ADDENDUM NO. 02

Baggage Screening Improvements – Phase 2B
[Baggage Handling Building Addition and OSR Room]

PROJECT NO. A044-09002-02

DATE OF ADDENDUM: February 07, 2012

1 TYPICAL MANHOLE SECTION DETAIL
 NO SCALE

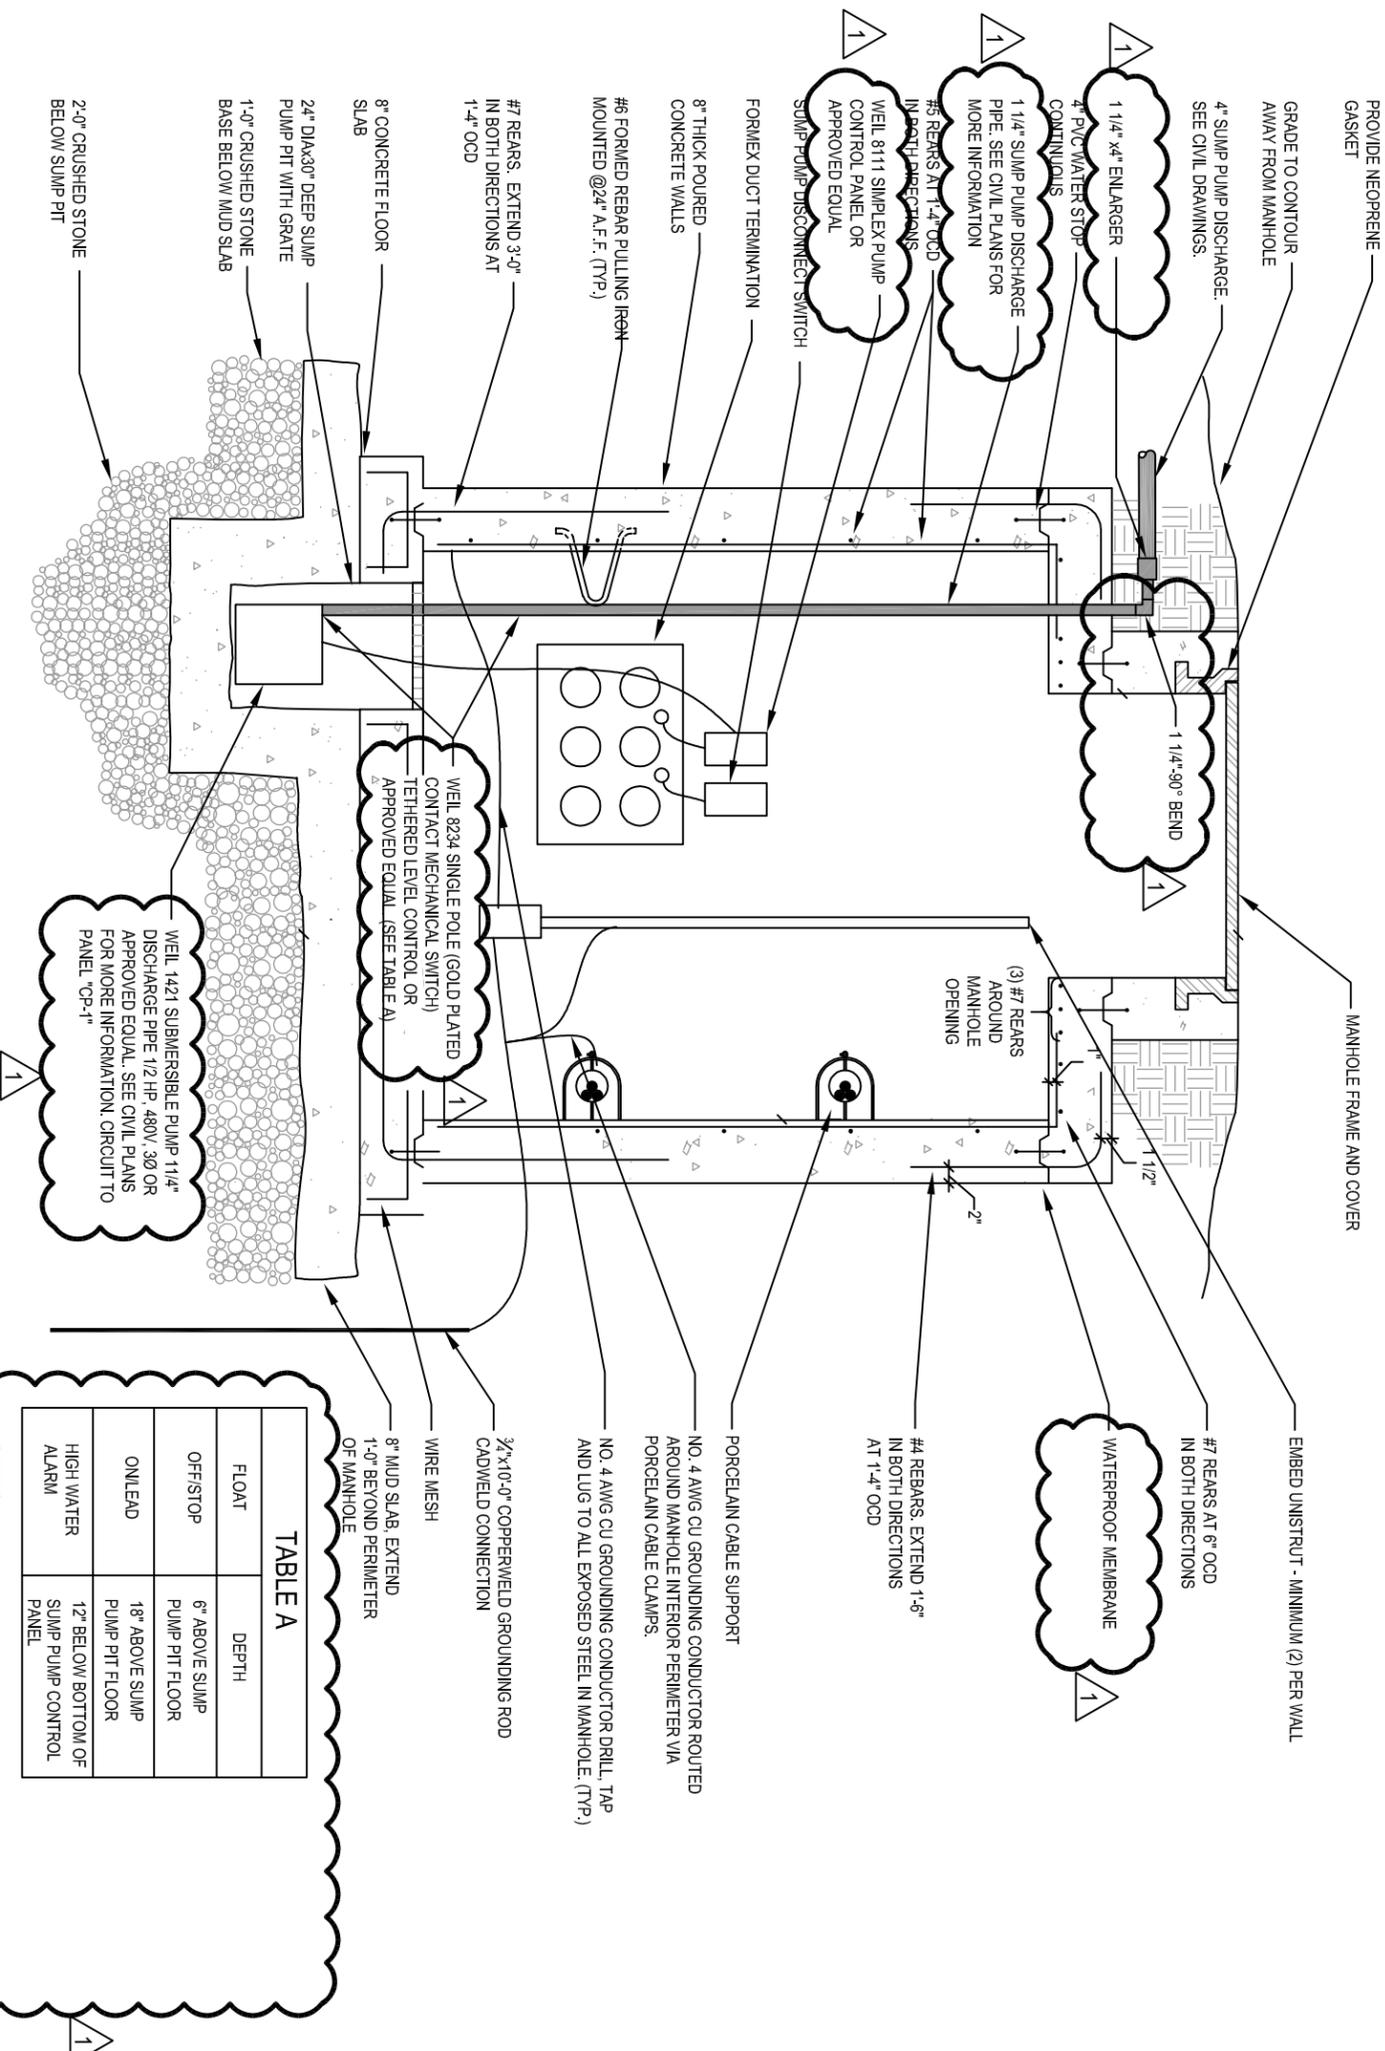
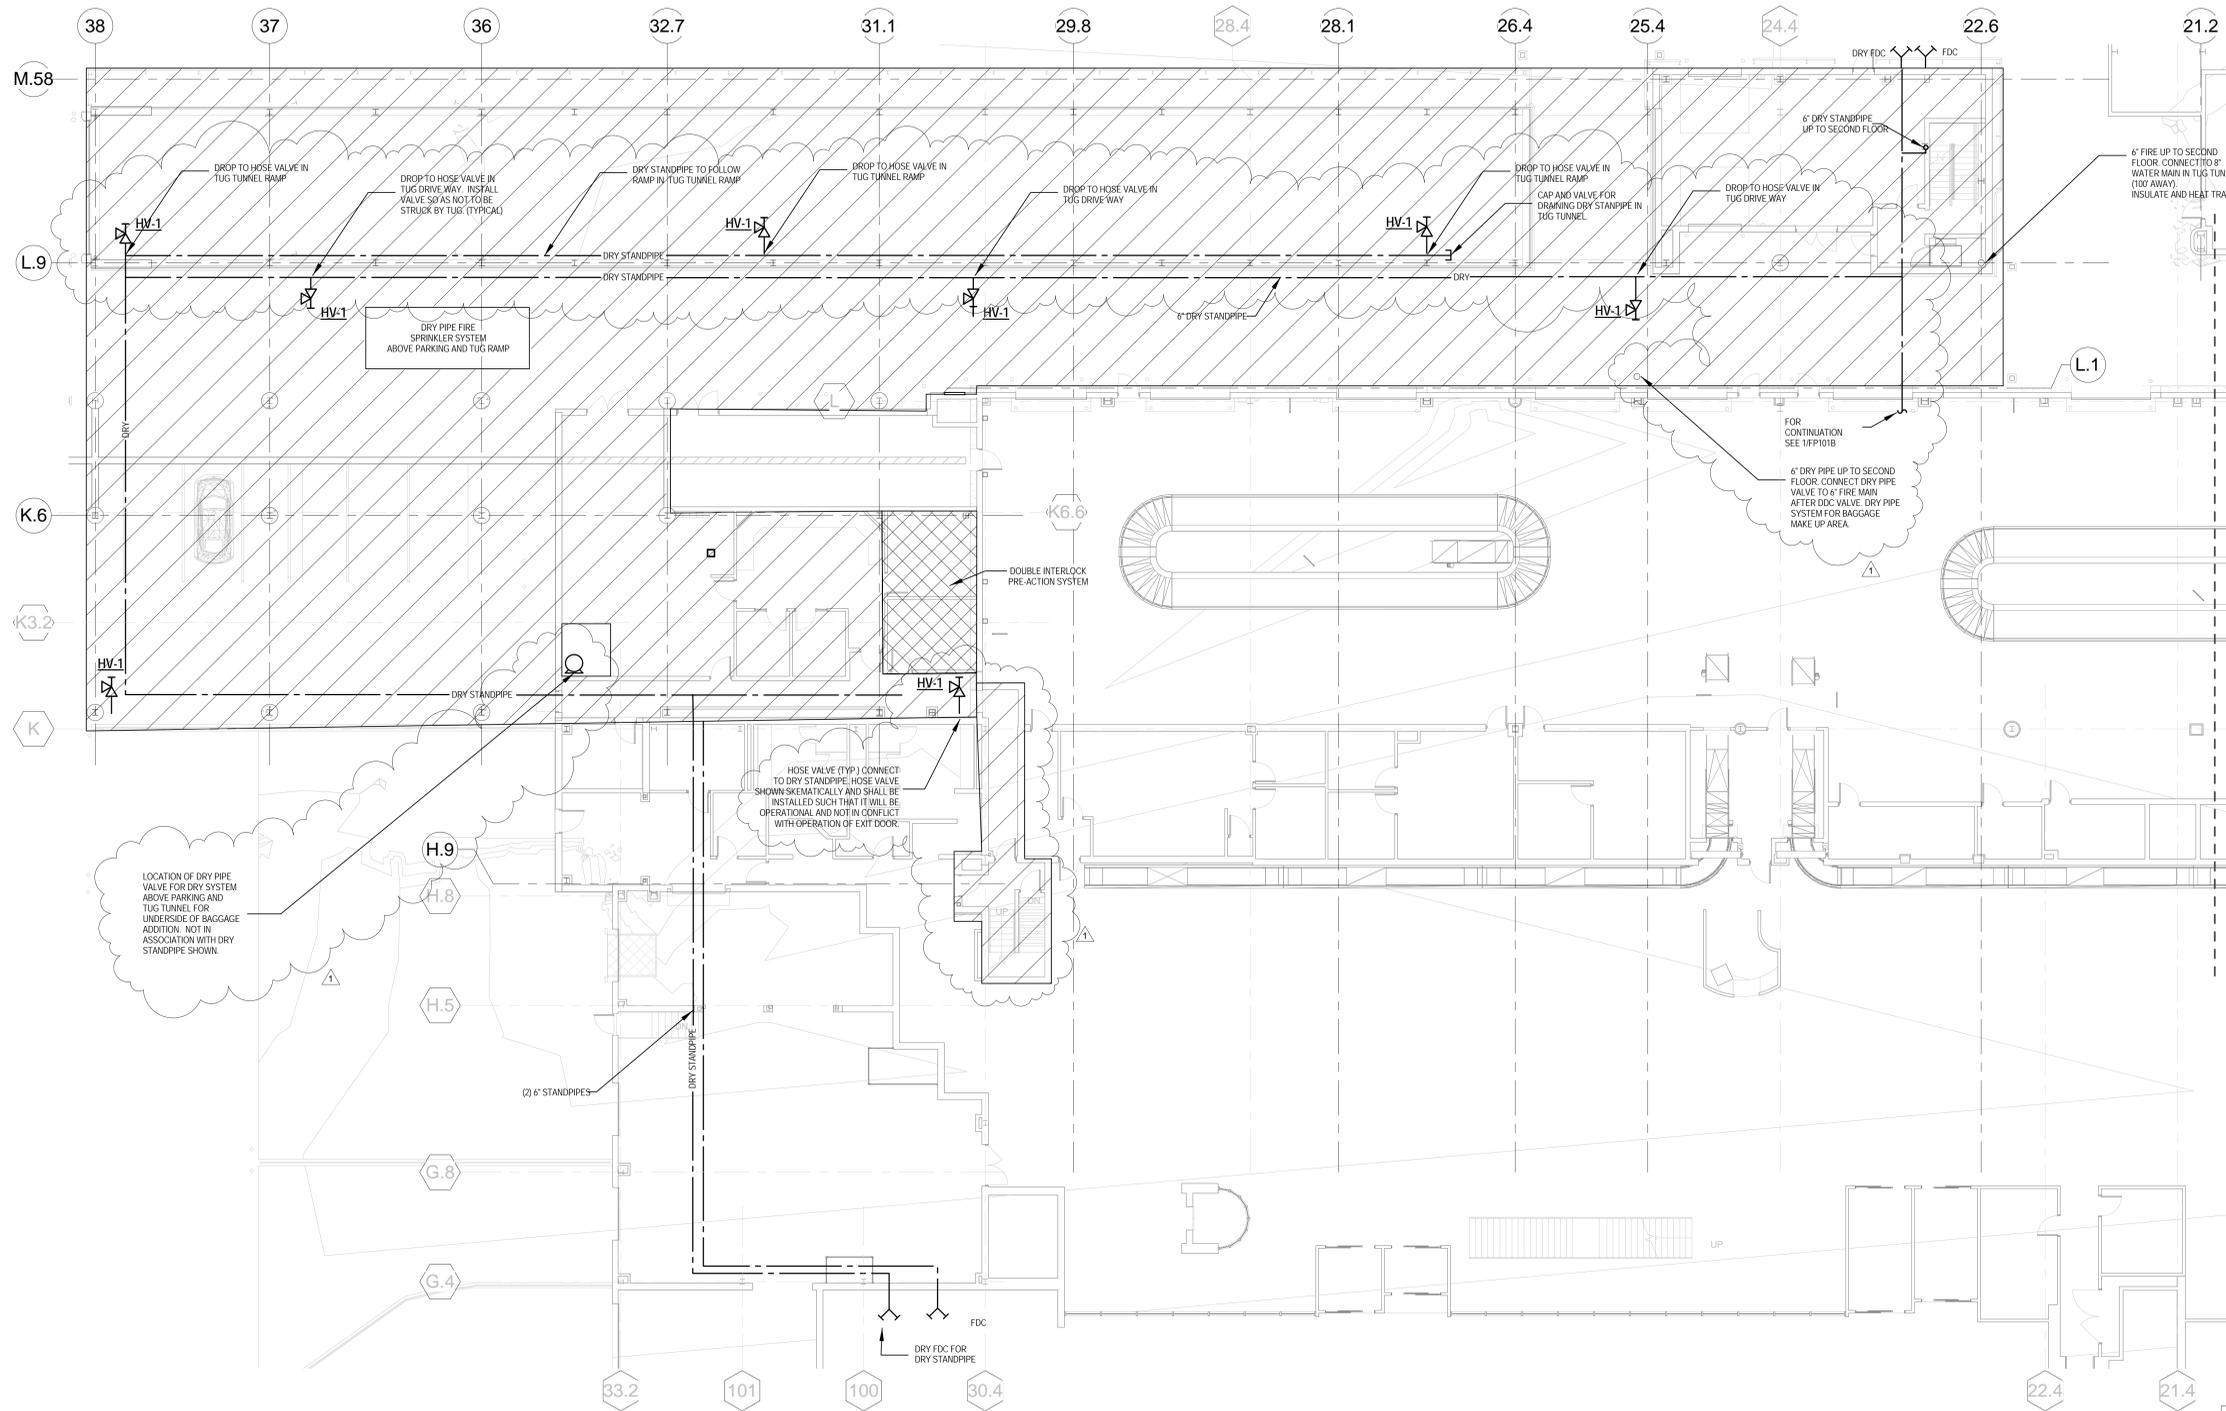
CHANGE Detail 1/E702B – Manhole

Added detail design information for the submersible pump, level control floats, submersible pump control panel, and submersible discharge piping.

1 OVERALL GRADE LEVEL FIRE PROTECTION PLAN
3/32" = 1'-0"

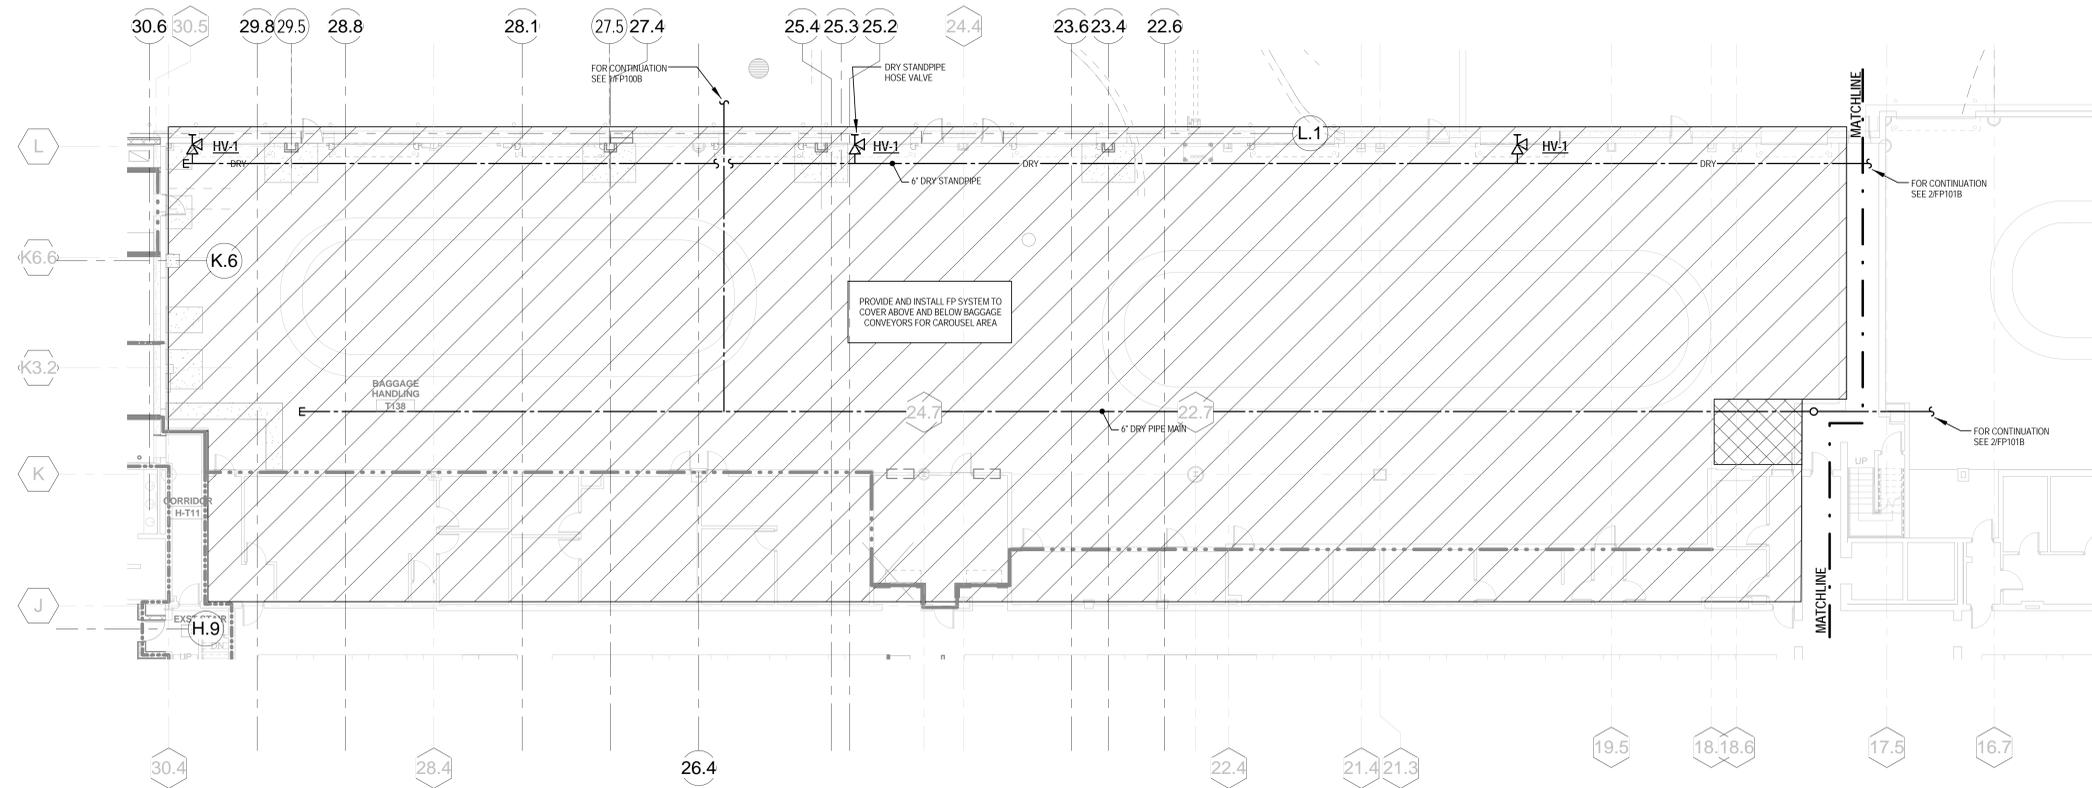
ADD note: “6” Dry pipe up to second floor. Connect dry pipe valve to 6” fire main after DDC valve. Dry pipe system for baggage make-up area.” **ADD** note: “Location of dry pipe valve for dry system above parking and tug tunnel for underside of baggage addition. Not in association with dry standpipe system.” **ADD** note: Drop to hose valve in tug tunnel driveway. Install valve so as not to be struck by tug. (Typical)” **ADD** note: “Cap and valve for draining dry standpipe in tug tunnel”. **ADD**: piping shown for dry standpipe running down tug tunnel. (See attached drawing FP100B)
